UNITED STATES PATENT AND TRADEMARK OFFICE

Office Action Summary

10/510,111

HIROTA ET AL.

FIG. 11

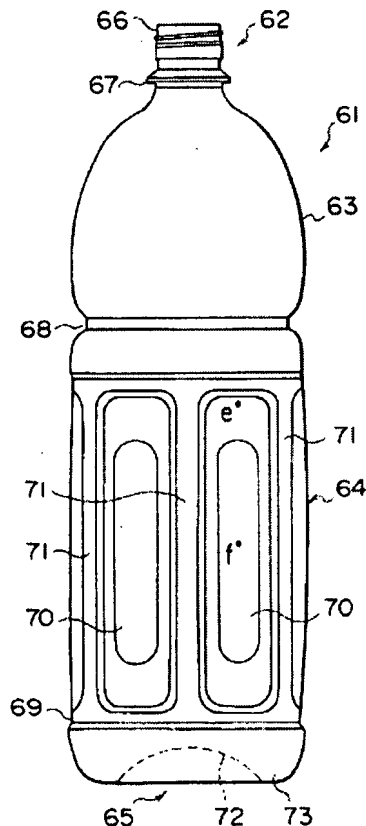
Regarding claim 1, Nakamaki ('420) teaches a heat-resistant polyester container (col. 1, ll. 13-19 and FIG-11, #64) with a barrel portion (FIG-11, #63).

Regarding claim 2, Nakamaki ('420) teaches panels in the barrel portion (FIG. 11, #70 and #64).
